DOCKETED	
Docket Number:	26-OPT-01
Project Title:	Vaca Dixon Power Center Project
TN #:	273054
Document Title:	Project Description Update
Description:	Project Description Update to incorporate water supply and project design changes
Filer:	Adam Morrison
Organization:	Rincon Consultants, Inc.
Submitter Role:	Applicant Consultant
Submission Date:	10/6/2026 11:34:50 AM
Docketed Date:	10/6/2026

Vaca Dixon Power Center Project CEC Docket No. 26-OPT-01

Project Description Update

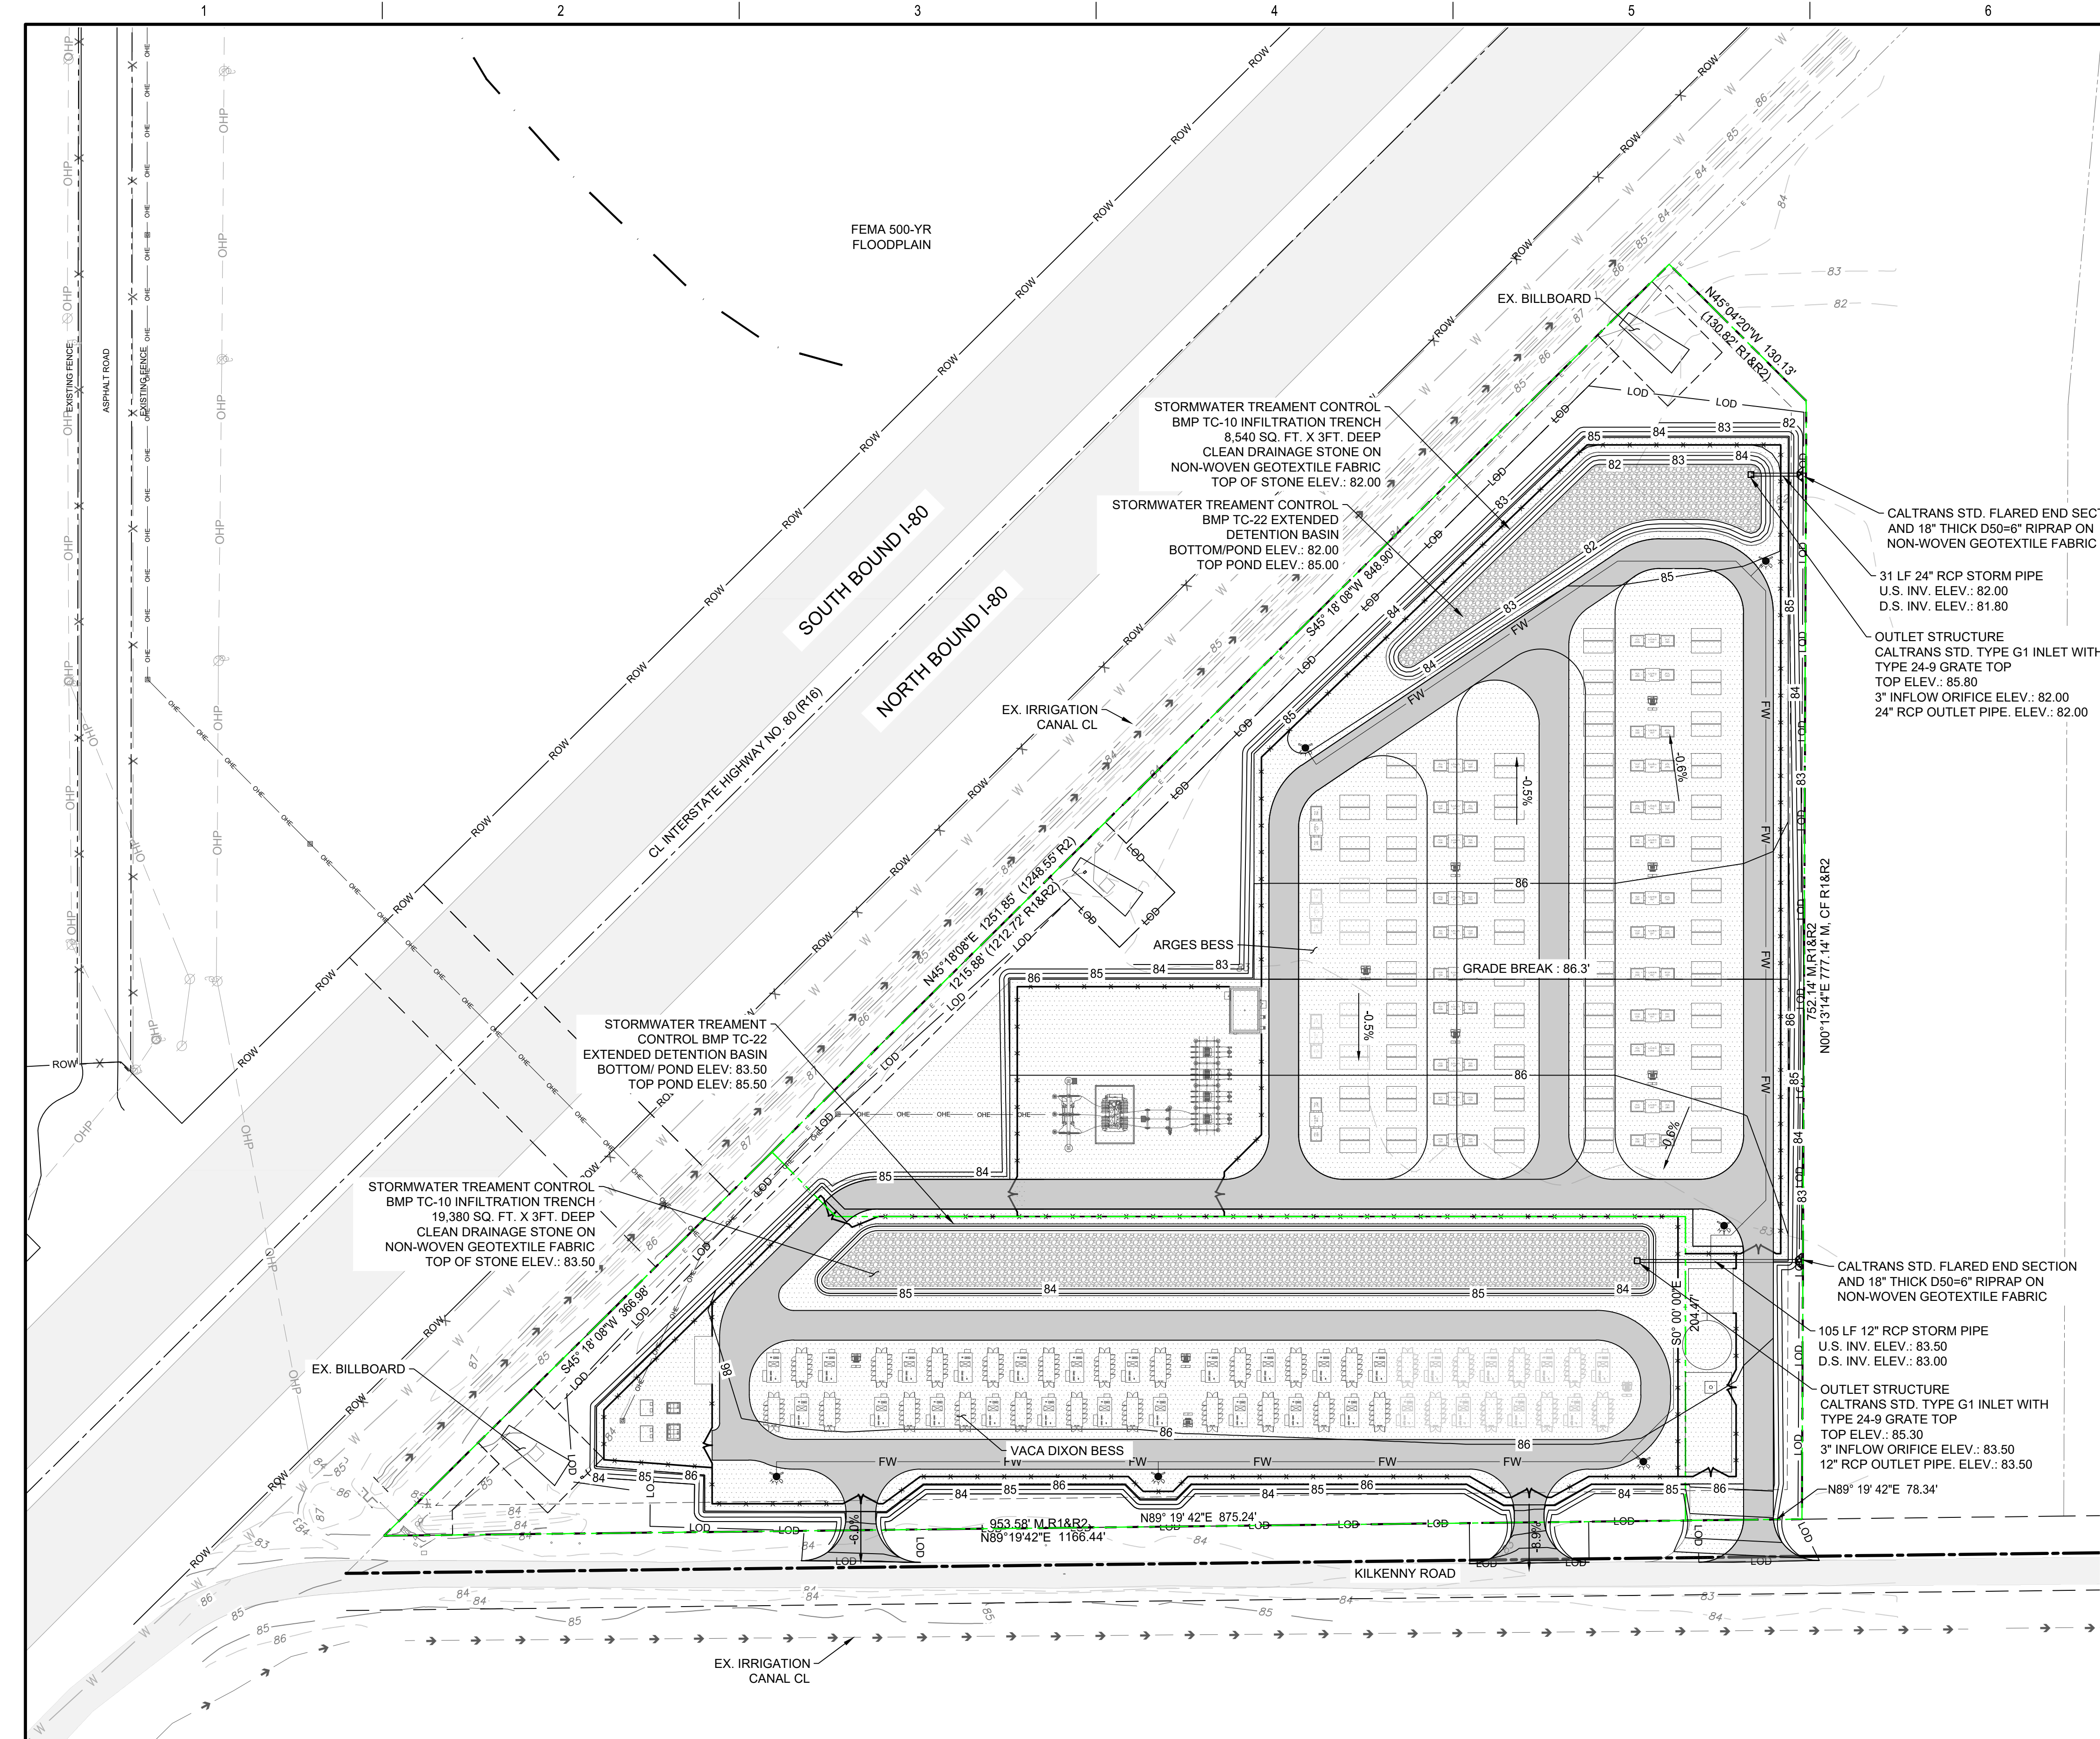
As depicted in the updated Project layout in Appendix A, the enclosure fence surrounding the Vaca Dixon Power Center facility would be extended in the southeast corner to enclose the groundwater well and associated pump skid and fire water storage tank. The overall Project area would not increase.

As depicted in the updated Project layout in Appendix A, the fire water loop located south of the Vaca Dixon BESS would terminate at the fire hydrant and would no longer connect to the City water main. Hydrant locations associated with the fire water loop would not change.

As depicted in the updated Project layout in Appendix A, the control enclosure in the Arges switchyard would be moved approximately 100 feet to the east along the enclosure fence and oriented north to south. No other changes associated with the control enclosure are proposed, and the overall disturbance footprint would not change.

As depicted in the updated Project layout in Appendix A, the medium voltage transformer locations would change, and the quantity of transformers would be reduced from ten to six. No other changes associated with the medium voltage transformers are proposed, and the overall disturbance footprint would not change.

As depicted in the updated Project layout in Appendix A, the arrangement of battery enclosures and associated PCS equipment within the Arges BESS facility have been revised to accommodate the updated BESS design. No other changes associated with the battery/PCS chains are proposed, and the overall disturbance footprint would not change.

As depicted in the updated Project layout in Appendix A, the control enclosure in the Vaca Dixon switchyard has been moved approximately 20 feet to the east along the enclosure fence and oriented north to south. No other changes associated with the control enclosure are proposed, and the overall disturbance footprint would not change.

As depicted in the updated Project layout in Appendix A, the Vaca Dixon BESS layout has been revised by rearranging the battery enclosures and associated equipment to accommodate the updated BESS design. This design modification does not alter the overall Project disturbance footprint.

MIDDLE RIVER POWER	JOB NUMBER	REV
VACA DIXON & ARGES BESS	US0054599.1425	△
GRADING & DRAINAGE PLAN	DRAWING NUMBER	C03-01-02

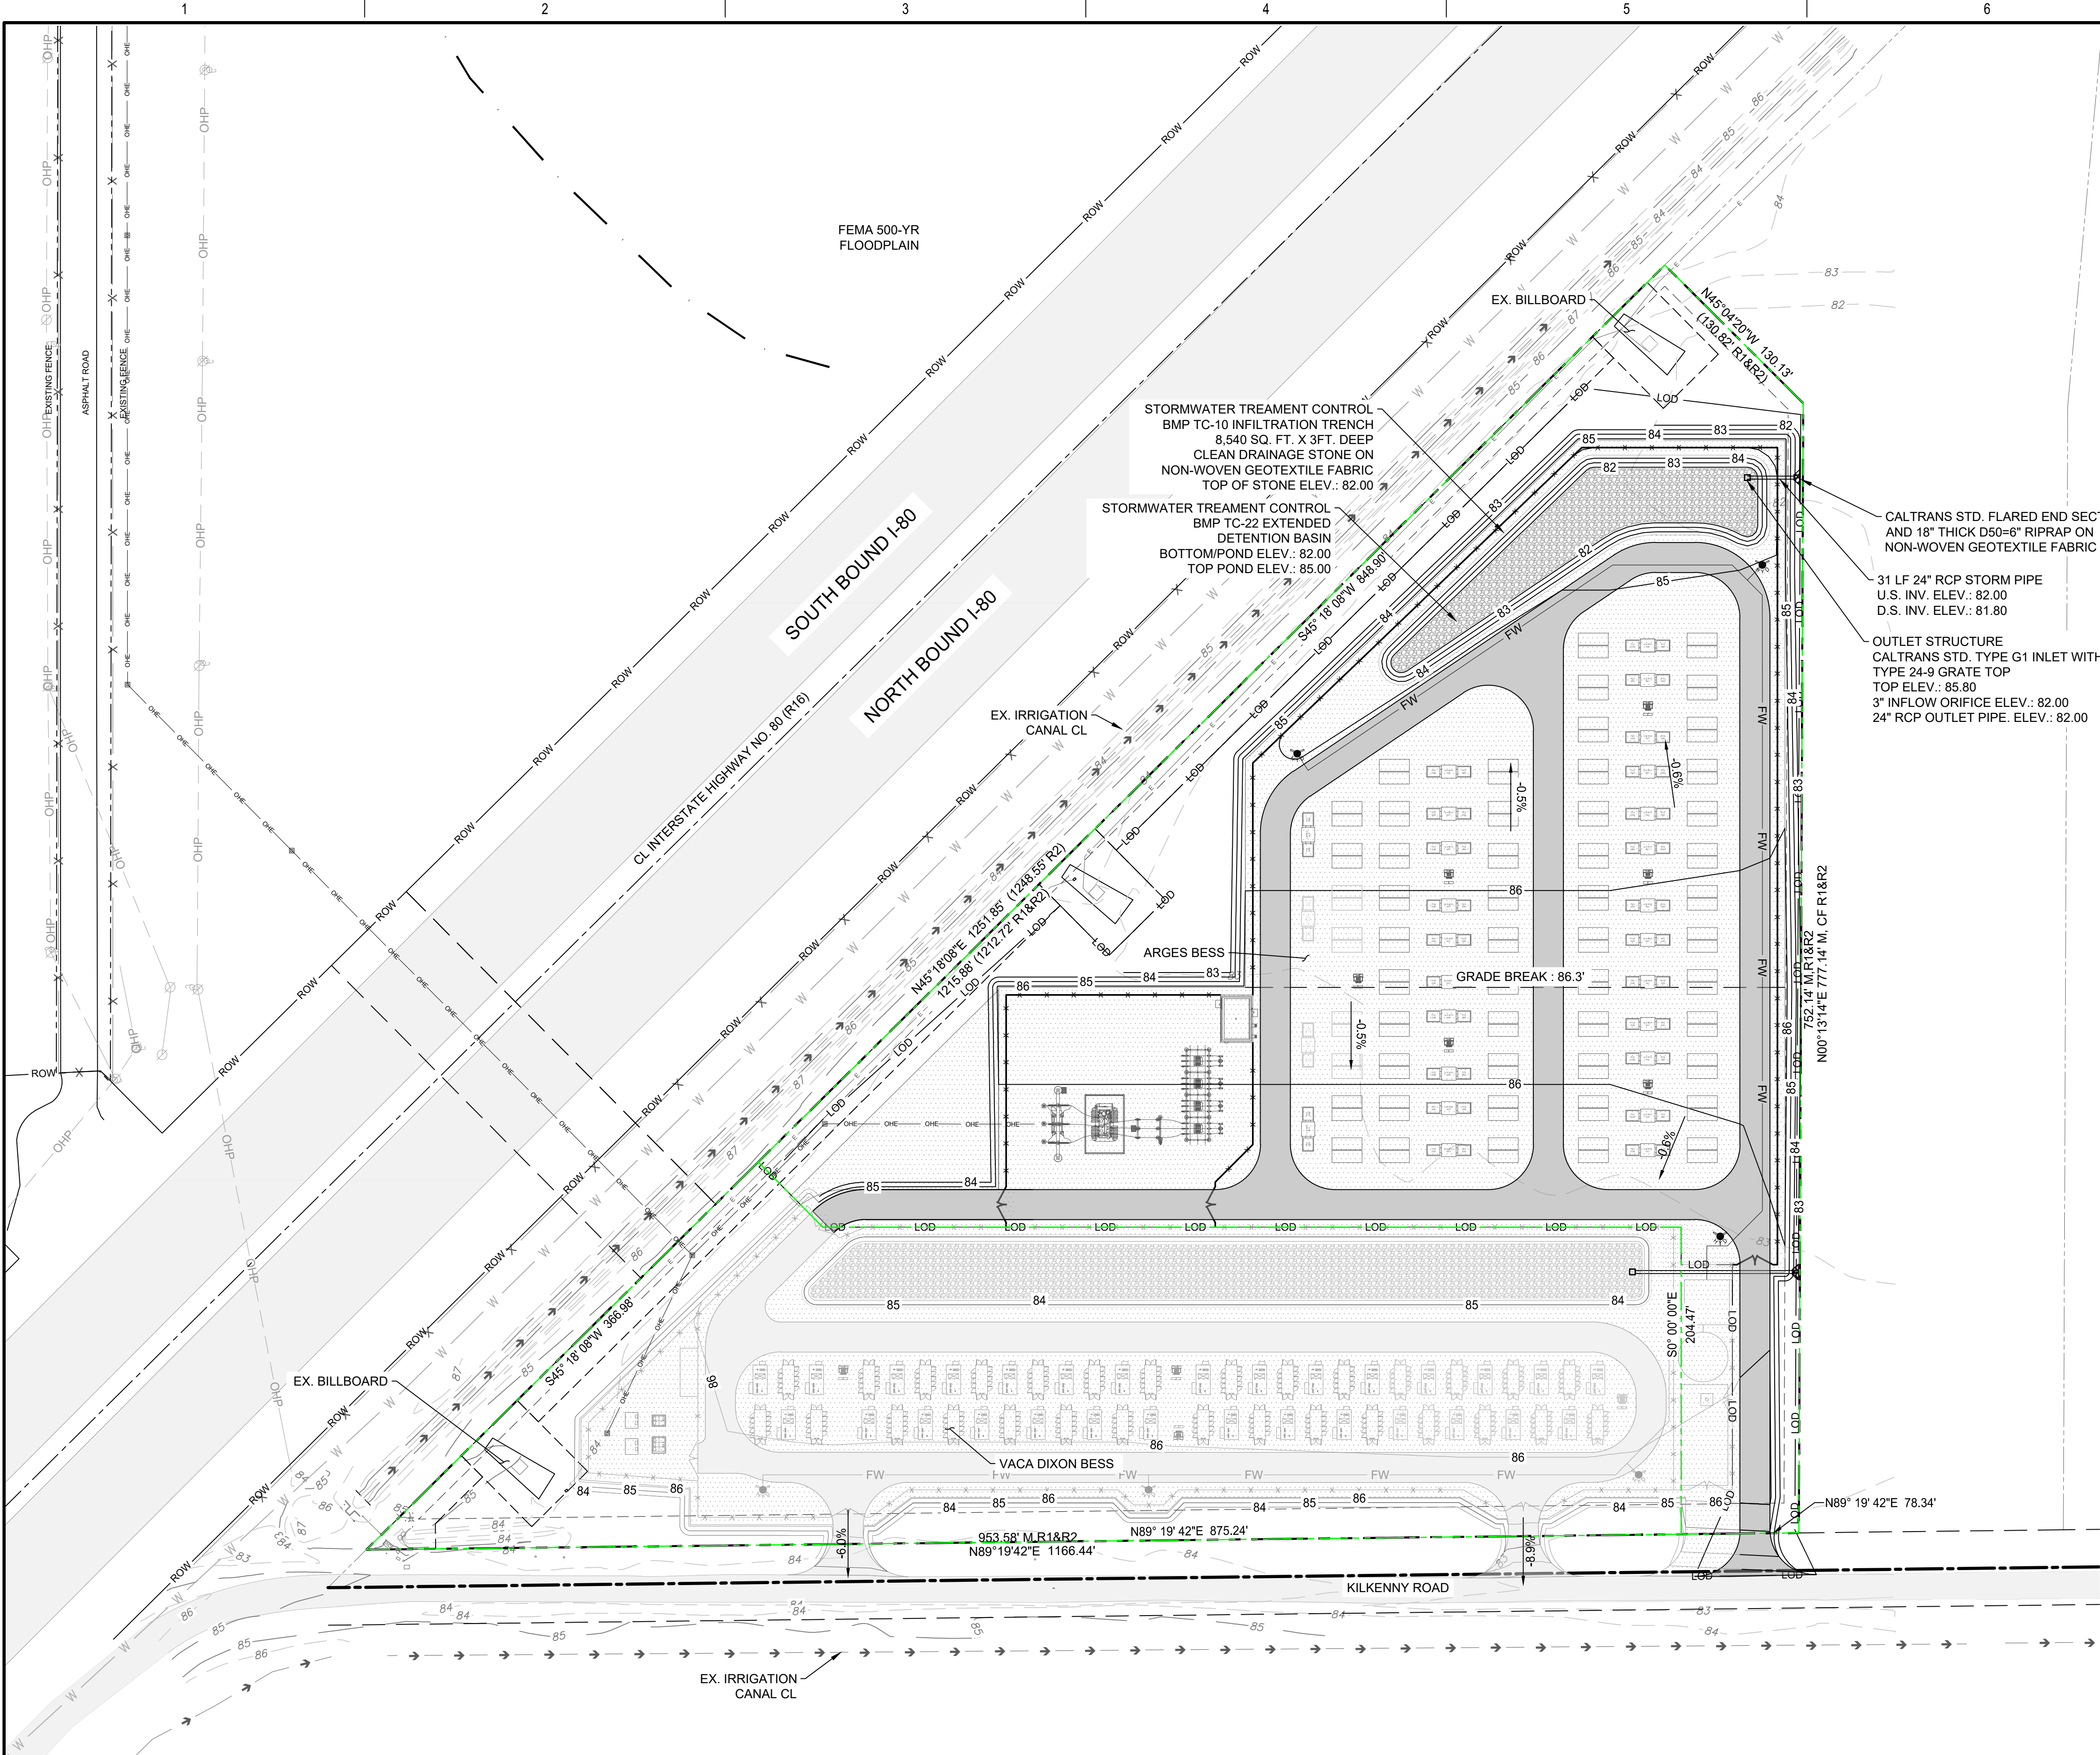
The updated Project layout is presented in Appendix A, and the updated grading and drainage plan is presented in Appendix B. The existing key observation point (KOP) photographs and updated simulated views are provided in Appendix C.
